# CORNEJO EAST ADDITION

## WICHITA, SEDGWICK COUNTY, KANSAS

RE: SUB 2002-110 -- One-Step Final Plat of Cornejo East Addition

**STAFF REPORT**  
**(ONE-STEP FINAL PLAT)**

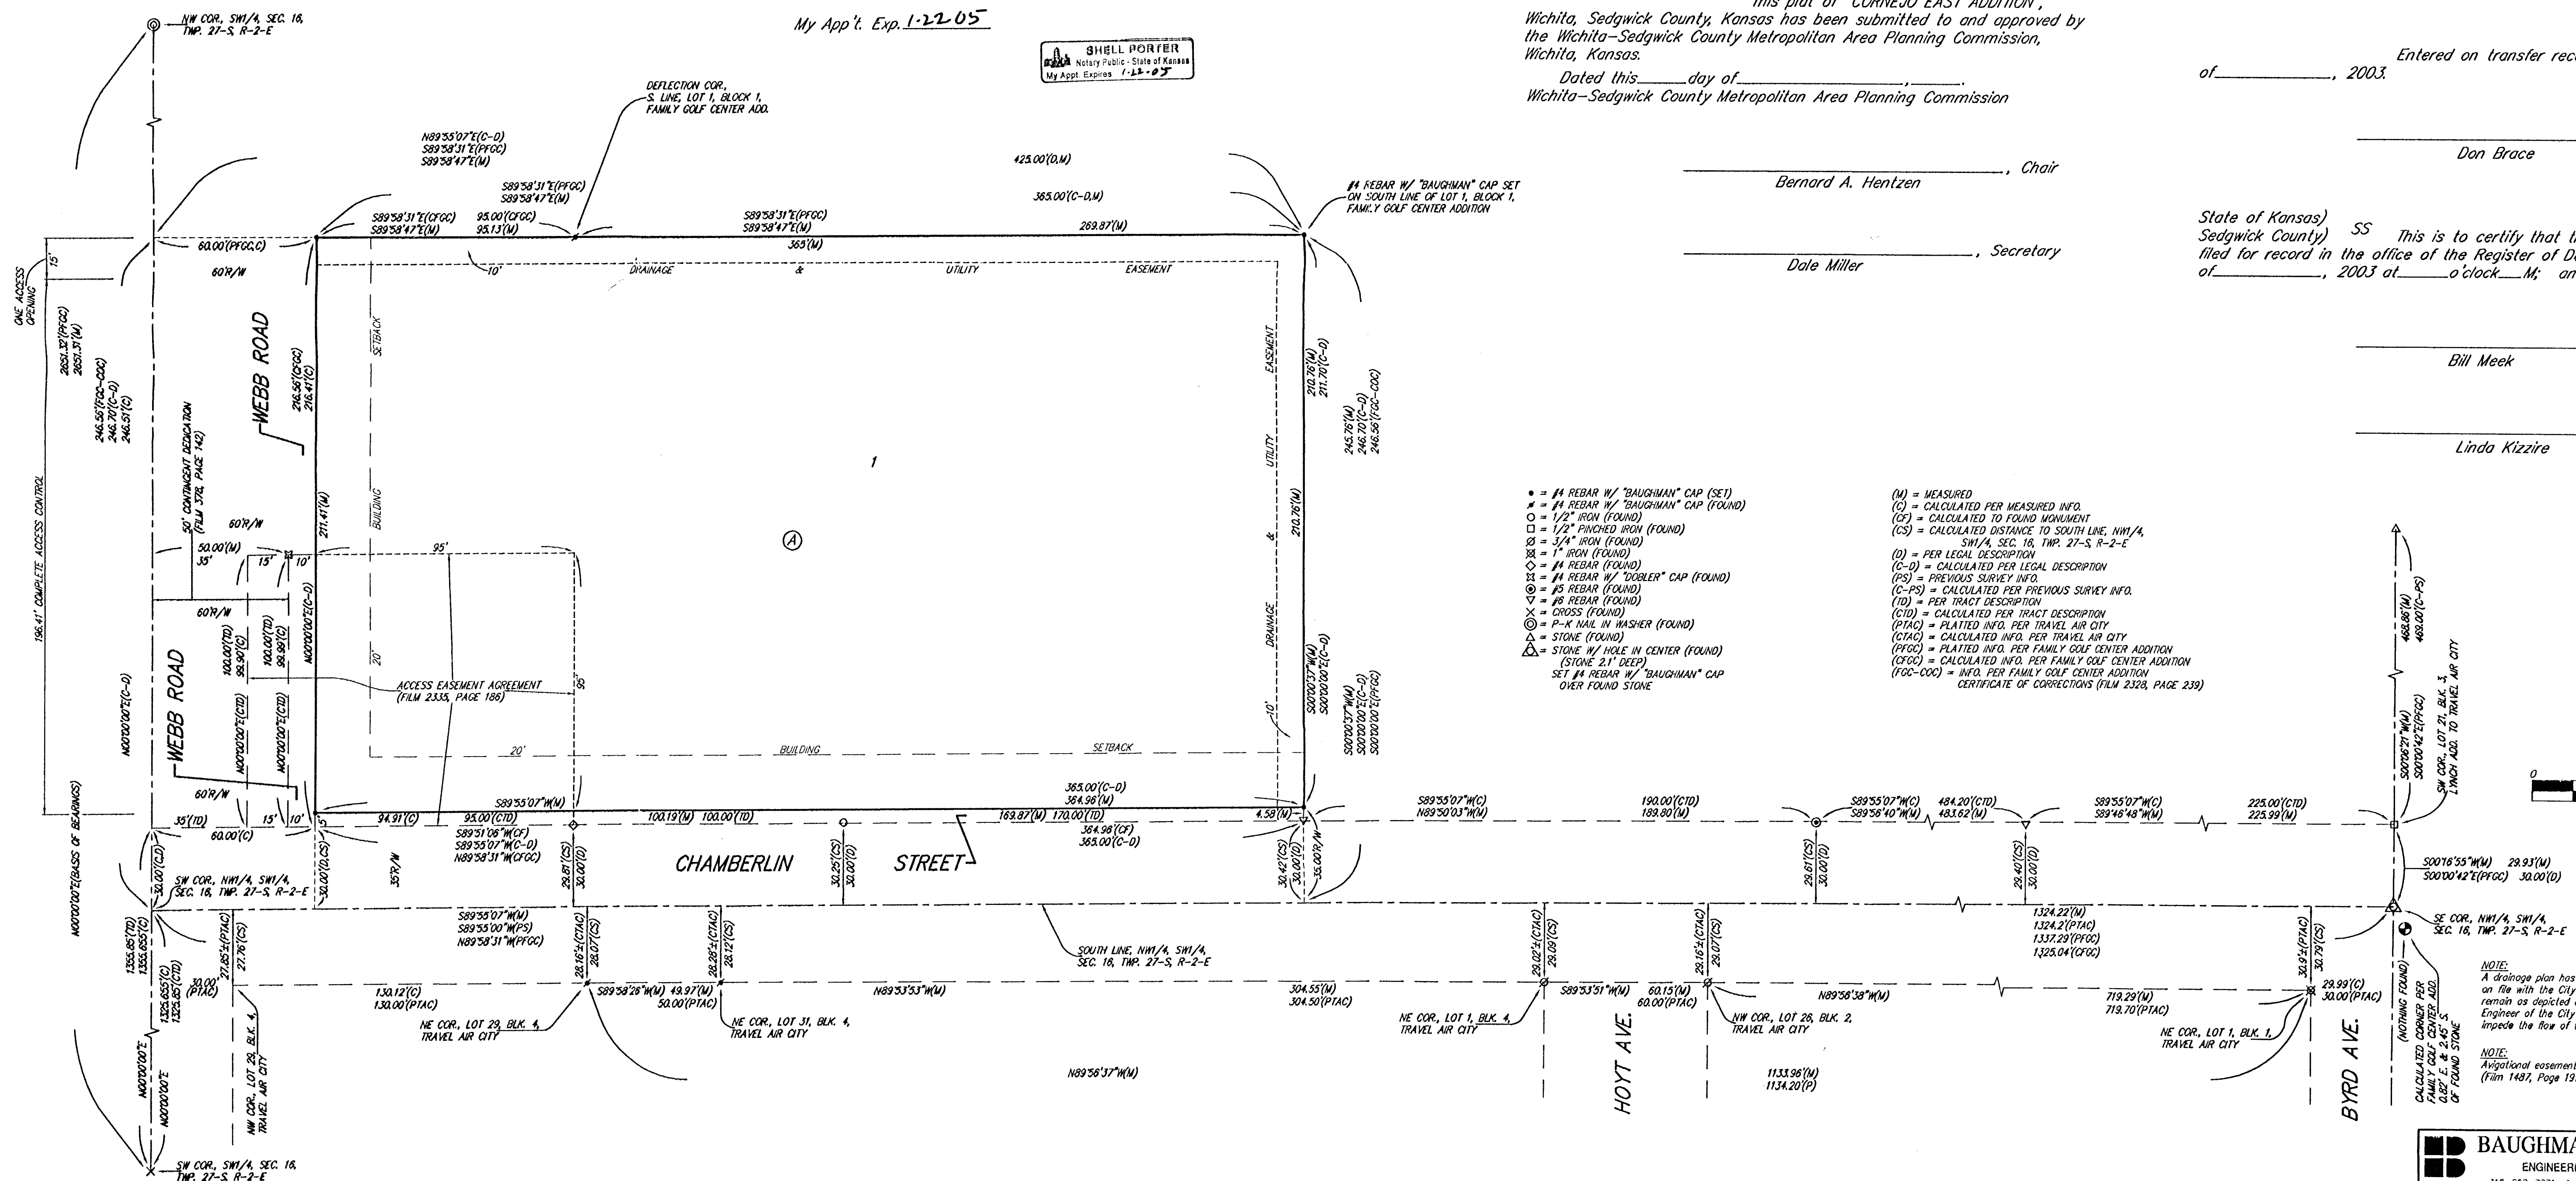
- C. City Engineering needs to comment on the status of the applicant's drainage plan. City Engineering has required on-site detention or a cross-lot drainage agreement.

- D. Traffic Engineering needs to comment on the access controls. The plat proposes one access opening along Webb Road. The final plat shall reference the dedication of access controls in the plat's text. Traffic Engineering requests the dedication of access control along Webb Road, except for one opening within the north 15 feet of the property.

- E. Traffic Engineering needs to comment on the need for additional right-of-way along Chamberlain in accordance with the 70-ft commercial street standard. An additional 5-ft right-of-way is requested.

- G. Traffic Engineering has requested the Applicant to guarantee the paving of Chamberlain abutting the property to the business/industrial street standard.

- I. The Applicant is advised that if platted, the building setbacks may be reduced to 20 feet.
- J. The owners noted in the platting binder need to be signatories to the plat, or a revision to the binder showing that the site's ownership is only in the party now shown on the final plat.

- K. The platator's text shall include language that a drainage plan has been developed for the plat and that all drainage easements, rights-of-way, or reserves shall remain at established grades or as modified with the approval of the applicable City or County Engineer, and unobstructed to allow for the conveyance of stormwater.
